SUBJECT: MILLSTONE POWER STATION, UNIT NO. 2 - ISSUANCE OF AMENDMENT
RE: ADMINISTRATIVE CHANGES AND CORRECTIONS TO THE TECHNICAL
SPECIFICATIONS (TAC NO. MF3870)

Amendment No. 320
Renewed License No. DPR-65

SAFETY EVALUATION BY THE OFFICE OF NUCLEAR REACTOR REGULATION

MILLSTONE POWER STATION, UNIT NO. 2

FIGURE 2.2-2 Local Power Density - High Trip Setpoint Part 2 (QR_2 Versus Y_1)

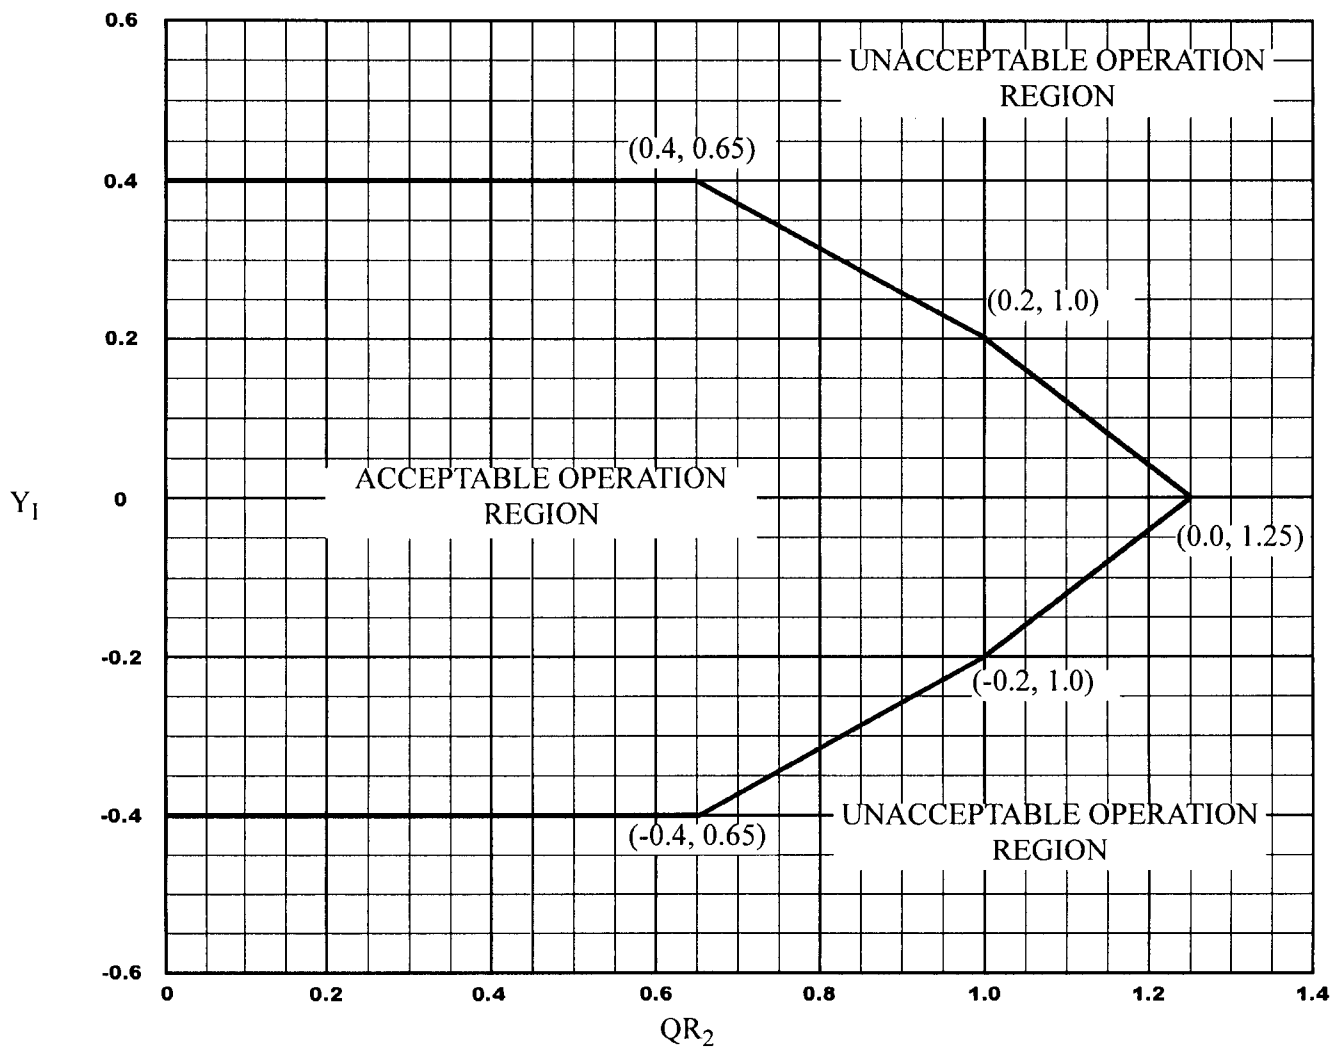
3.2 Correction to Figure 2-2-2

Replace figure number "2-2-2" on TS Page 2-7 with "2.2-2."

The figure number on TS Page 2-7 for Figure 2-2-2, "Local Power Density - High Trip Setpoint Part 2 (QR₂ Versus Y₁)," is incorrect. This is a typographical error.

3.3 Corrections to Figure 2-2-2 and 2.2-3

Replace "Y₁" (Y sub 1) in two locations in Figure 2-2-2 (to be relabeled as Figure 2.2-2 as noted in section 3.2, above) and in four locations in Figure 2.2-3, "Thermal Margin/Low Pressure Trip Setpoint Part 1 (Y₁ Versus A₁)," with "Y_I" (Y sub I).

There are six locations in these 2 figures where AXIAL SHAPE INDEX for the trip signals in the reactor protection system, is incorrectly labeled as "Y₁" (Y sub 1). As shown in the Definitions section of the MPS2 TSs, the symbol for AXIAL SHAPE INDEX for the trip signals in the reactor protection system, is "Y_I" (Y sub I).

This proposed editorial change is corrective in nature and does not involve any physical changes to SSCs in the plant, or the way SSCs are operated or controlled. Therefore, the proposed change is acceptable.

This proposed editorial change is corrective in nature and does not involve any physical changes to SSCs in the plant, or the way SSCs are operated or controlled. Therefore, the proposed change is acceptable.
